**Year 1 Monitoring Report**  
**FINAL**  
**Greenbrier Stream Mitigation Project**  
**Yadkin County, North Carolina**  
**Monitoring Year 1**

NCDEQ Contract No. 7616  
DMS ID No. 100086  
USACE Action ID No. SAW-2018-01755  
NCDWR ID: 20181272  
Yadkin River Basin  
HUC 03040101

**RE: Response to Draft MY1 Monitoring Report Comments dated December 2, 2020  
Greenbrier Stream Mitigation Site  
Yadkin River Basin – CU# 03040101 - Yadkin County, North Carolina  
NCDMS Project # 100086, Contract # 7616**

FIGURE 2

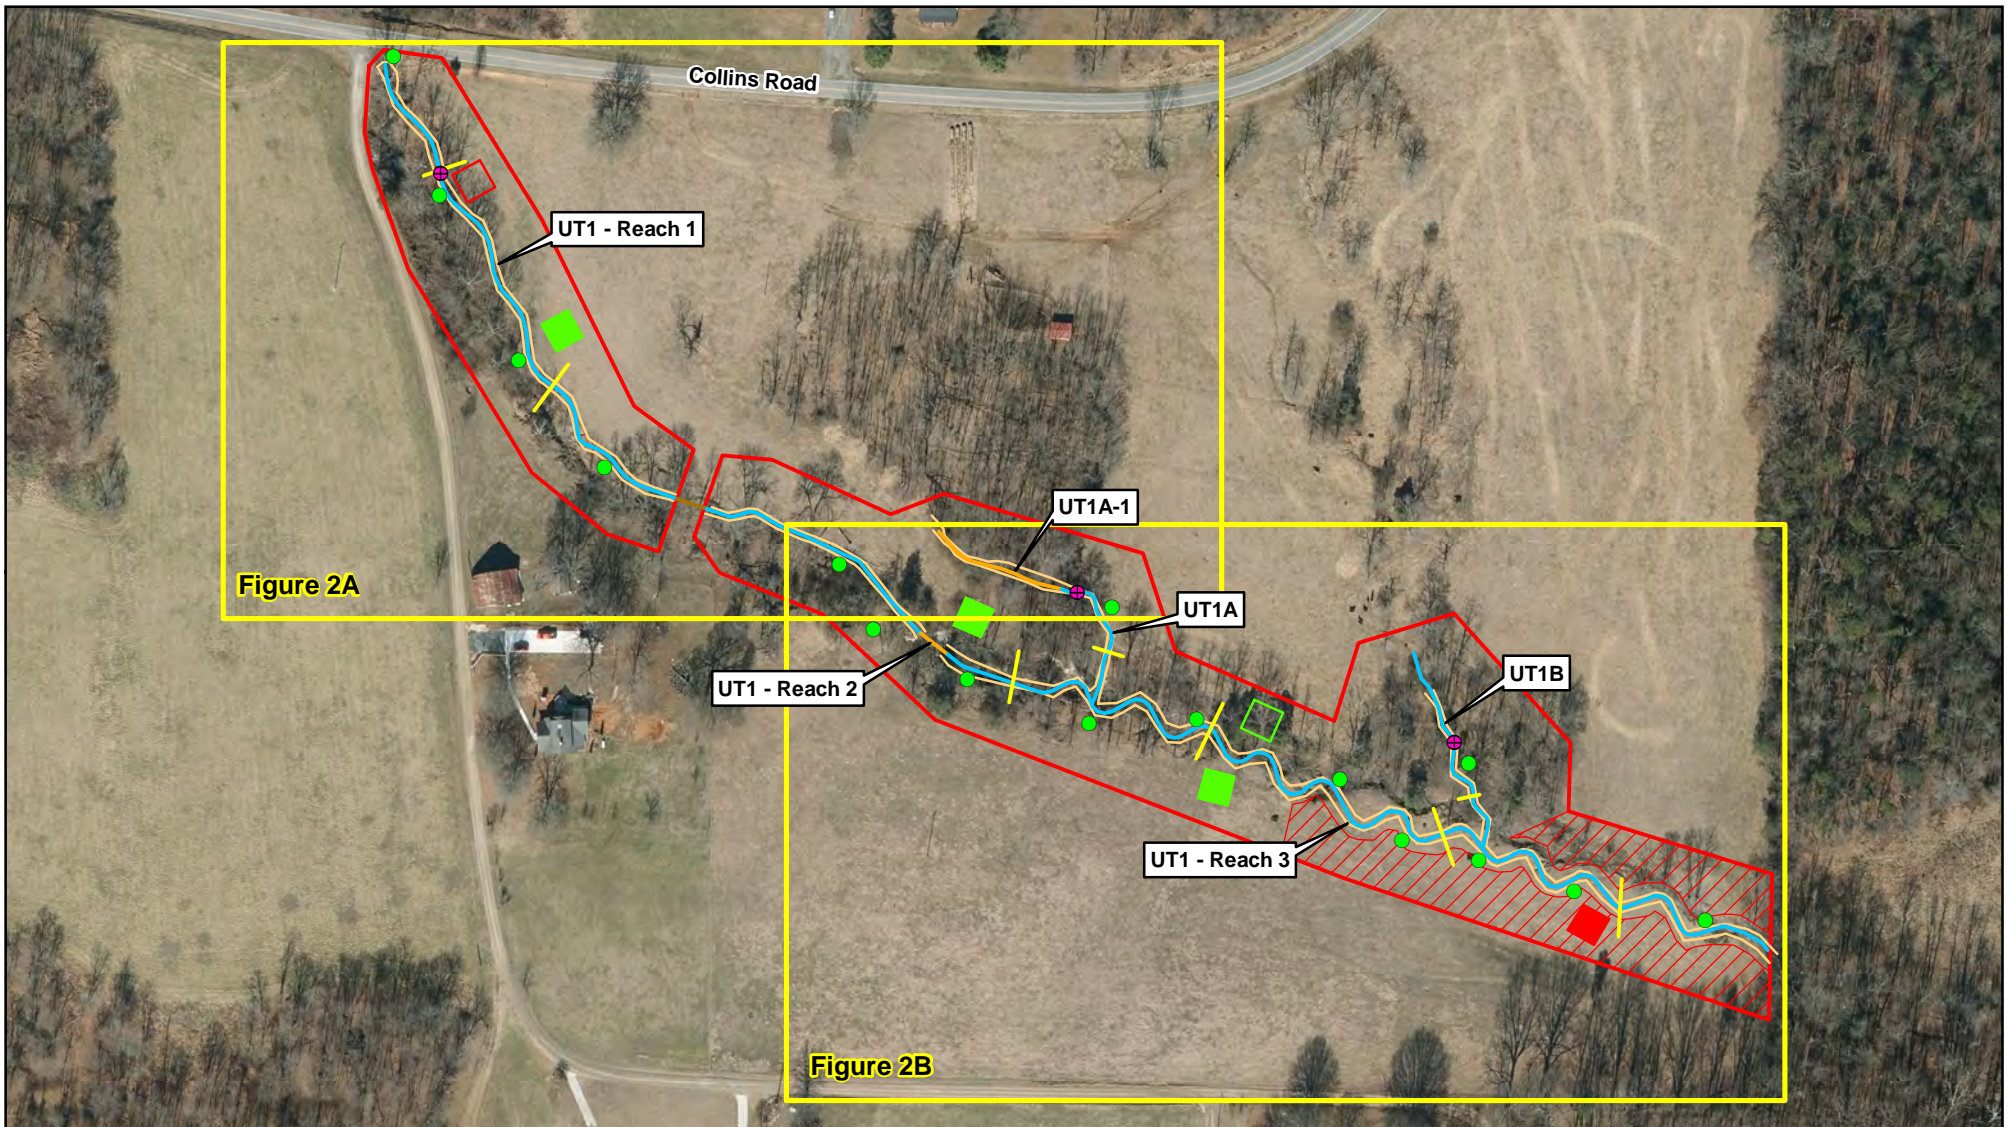
- **Tables 1 and 3 have been updated to reflect warm thermal regime.**
- *CCPV Maps: Since VP-4 is not meeting the MY3 interim success criteria of 320 stems/acre, it should be shown as “red” on the CCPV Maps. This should be updated in the MY2 report once the supplemental planting effort is completed and the plot meets the success criteria.*

- **VP-4 and RVP-1 are now shown as red on the CCPV maps.**
- *Table 6 & Table 7: Recommend showing the VP-4 stems/ acre cells (162 stems/ acre) as orange/ red since it is not meeting the MY3 interim success criteria of 320 stems/acre.*

FIGURE 2B

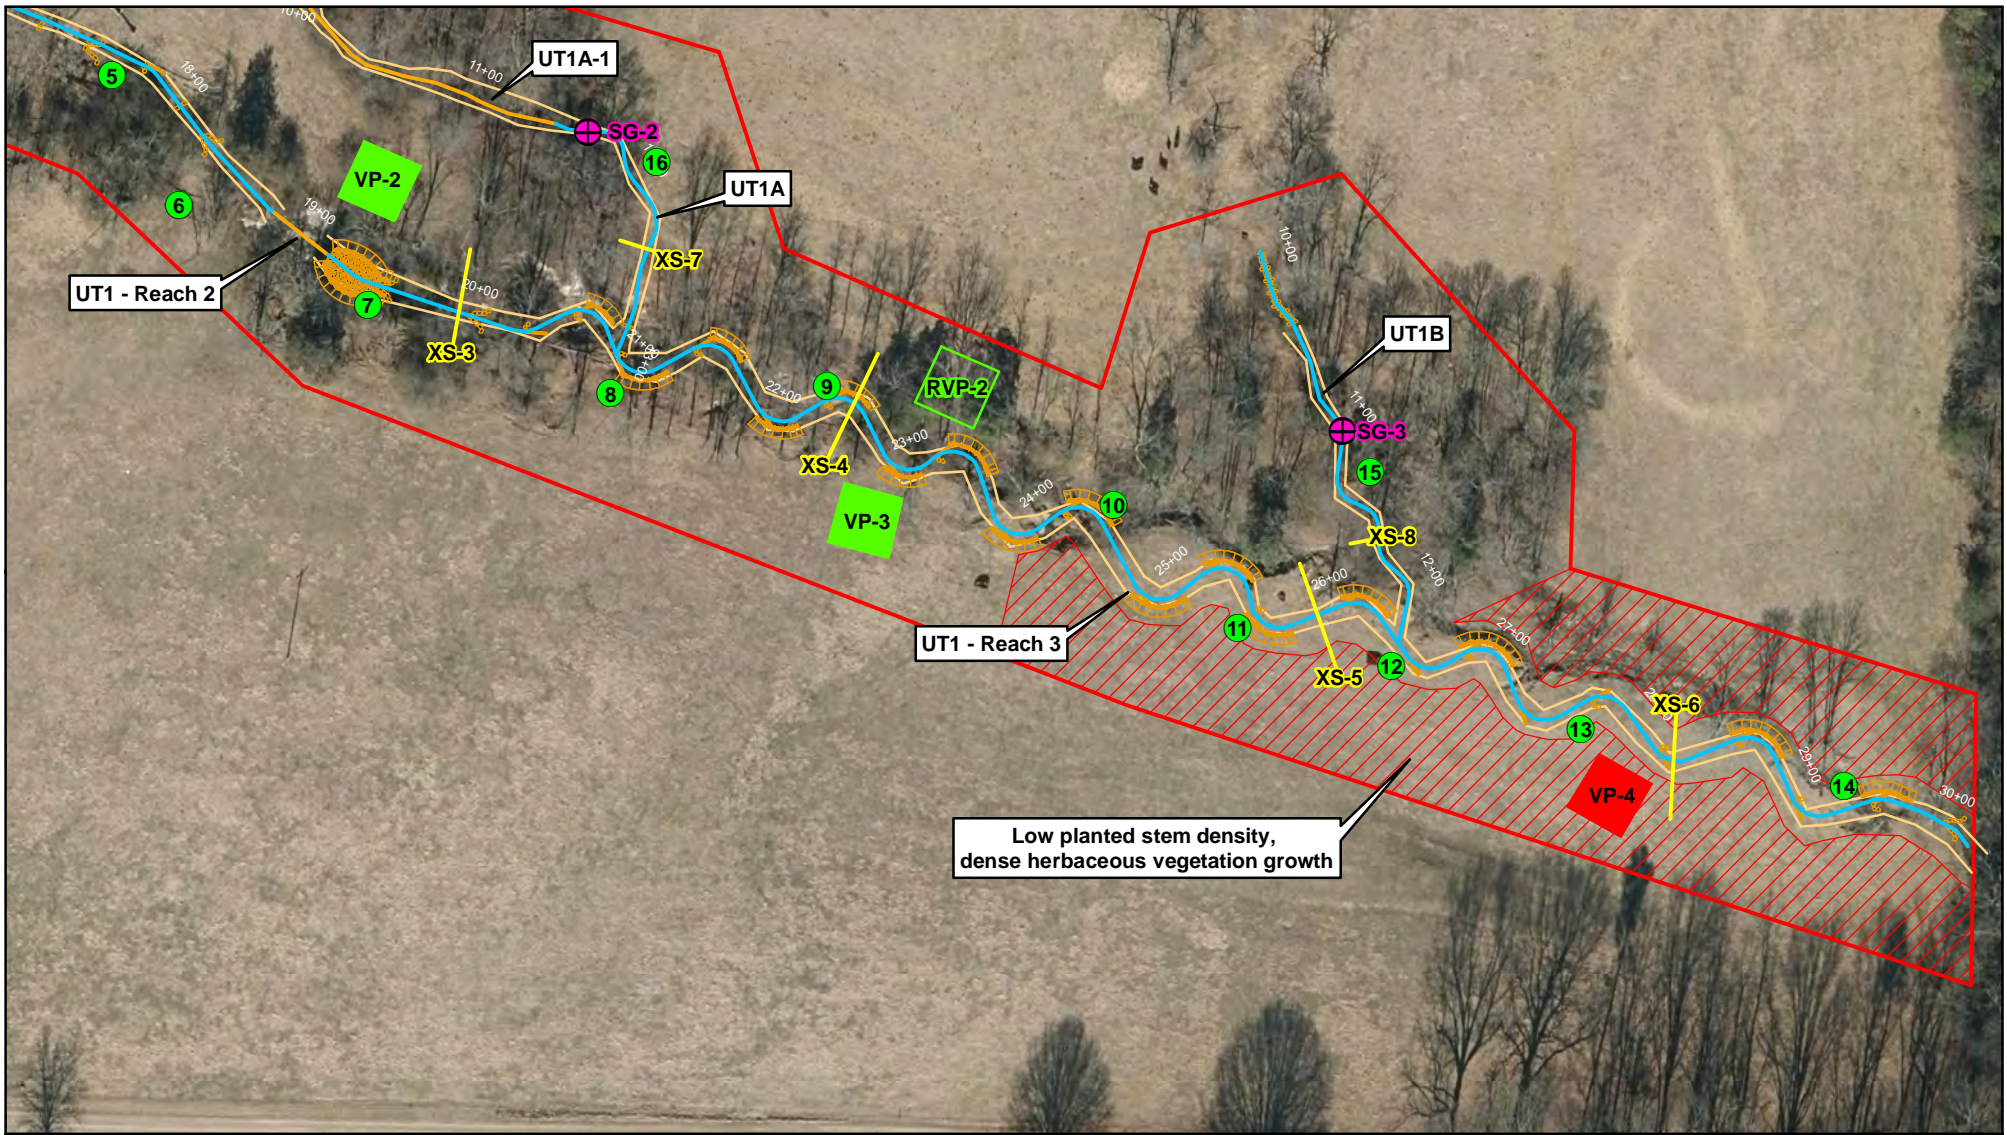
- *Please provide the spatial feature used to display the vegetation problem area in Fig. 2B.*
  - **The spatial feature shapefile *Greenbrier\_Veg\_Problem\_Areas* has been added to the digital submittal.**
- *In an effort to ensure that DMS has features that represent the creditable lengths or areas, the mitigation plan features were reviewed. In the mitigation plan design features, UT1B has a length of 232 ft, but is reported as 247.5 ft in the asset table. If possible, please resubmit the mitigation plan features ensuring that the feature lengths match reported lengths.*

PCN FIGURE 1

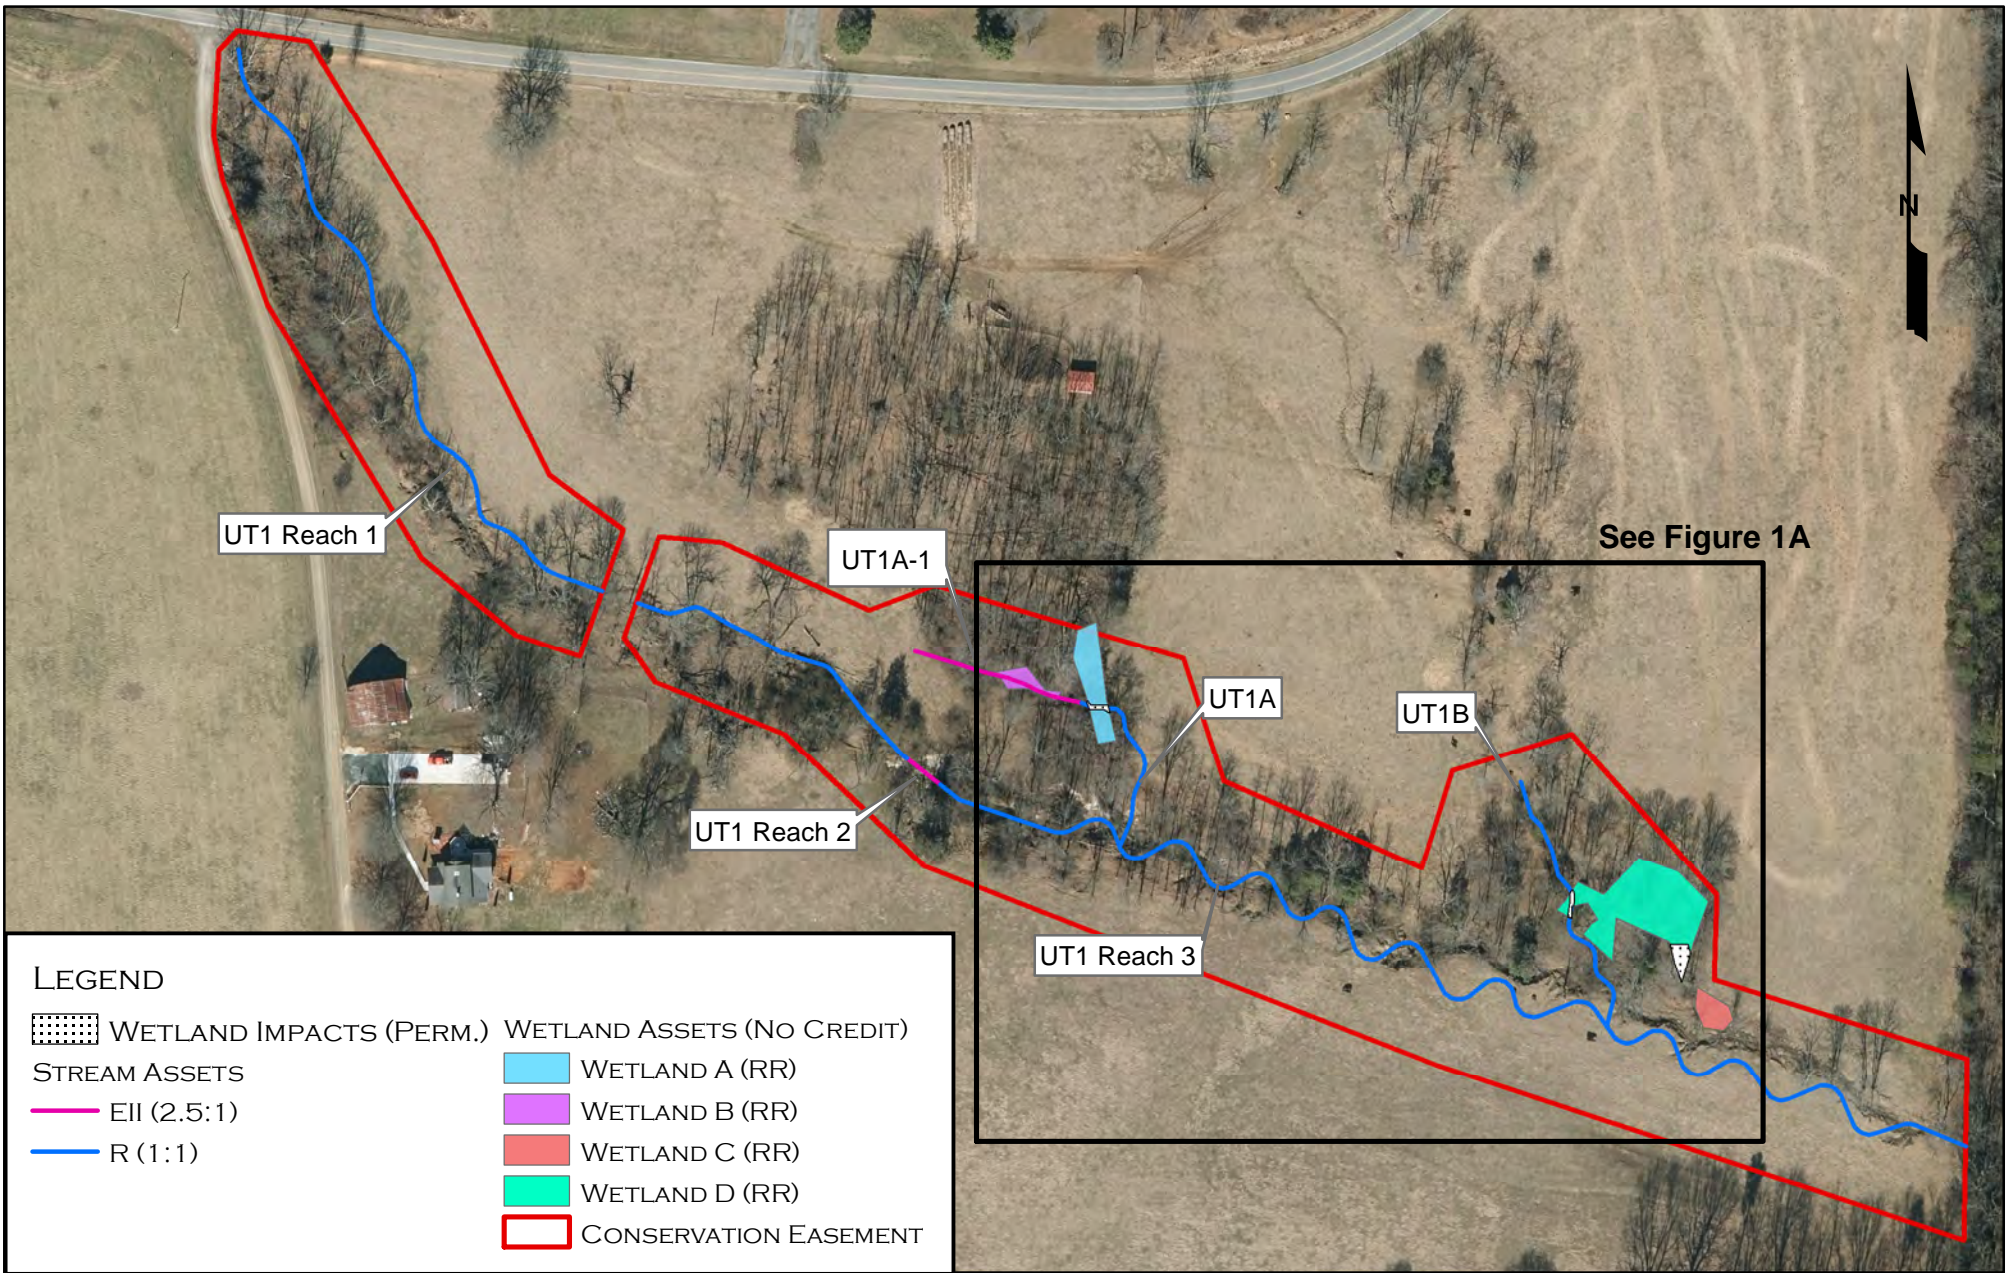
1. Will you please verify that the new alignment did not impact the existing wetlands that were around UT1A-1?
2. Since this is the as-built, shouldn't you know which species of trees are in each plot since they were just planted?

Given the realignment change for UT1A-1, was the proposed vegetative swale feature also constructed in a new location?

1. The alignment change was above Wetland B (see attached map included with the permit/PJD) and only shifted the upper approximately 40' of UT1A-1 slightly north.
2. We know the species planted on the site per the vegetation plans (species, densities, percentage of each species). When the sites are planted, hundreds of bare-root stems that essentially look like sticks are mixed by hand into sacks so that workers can grab a stem out of the sack, use a dibble bar to open a hole in the ground and plant a bare root, take a couple step and repeat. Identifying which species a tree/shrub is when they essentially look like sticks poking out of the ground can be very difficult and inaccurate which is why we decided to wait until MY1 to identify the species accurately.

The original proposed alignment was incorrect due to survey error. The original alignment did not connect to the low valley point and hydrology source. The realignment was needed to connect to the existing swale and source of hydrology above UT1A-1. This existing swale impounds some water and is vegetated and buffered by woody vegetation. It was determined during construction that clearing the woody vegetation to grade and plant herbaceous vegetation would create less functional improvement than leaving this feature as is.
